HORSHAM DISTRICT COUNCIL CONSULTATION

TO:	Horsham District Council – Planning Dept
LOCATION:	Land Parcel at 520241 133665 Wimland Road Faygate West Sussex
DESCRIPTION:	Application for approval of Reserved Matters pursuant to Condition 5 of Outline Planning Permission reference DC/16/1677 for the construction of a primary road through Sub Phase 2C, footpaths and cycleways, foul and surface water drainage including SuDS basins, landscaping, and associated infrastructure.
REFERENCE:	DC/26/0731
RE-CONSULTATION:	1 st set of comments in black 2nd set of comments in blue
RECOMMENDATION:	More Information / Modification Modification / Advice

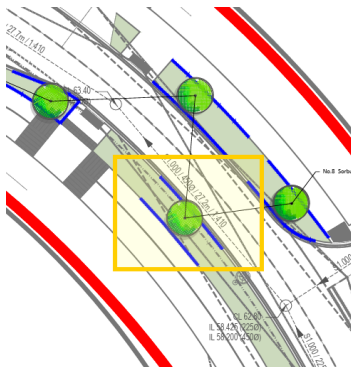
9. Clarify what replacement planting is being proposed in those areas where the existing landscape corridors are being removed to facilitate the construction of the road, as highlighted crudely in yellow (planting plan sheet 3 of 7 and 6 of 7)

Response dated 26/08/2026 is noted. The suggestion that the landscape proposals are of an appropriate level of compensatory planting is respectfully disagreed with, particularly given the maturity of the removed landscape corridors in contrast with the juvenile specimens provided, as per points 5 and 6. It has not yet been justified why suitable compensatory planting cannot be carried out within these areas in addition the landscape proposals elsewhere in the scheme. Please amend.

- Planting plan 4 of 7

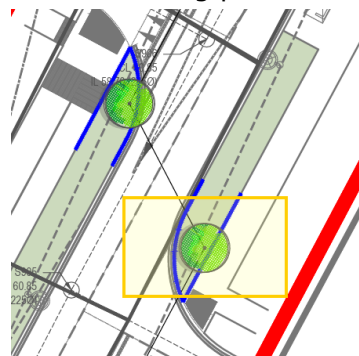
11. It is unclear if the proposed trees in some locations have enough clearance from proposed underground services. Some of these lines appear to be visibility splays, others I'm unclear if a proposed underground service is currently clashing with the landscape strategy. Of particular concern will be the street lighting. Please confirm or coordinate and adjust plans, some examples below (but not limited to, please review the full scheme):

Response dated 26/08/2026 is noted. Closed.
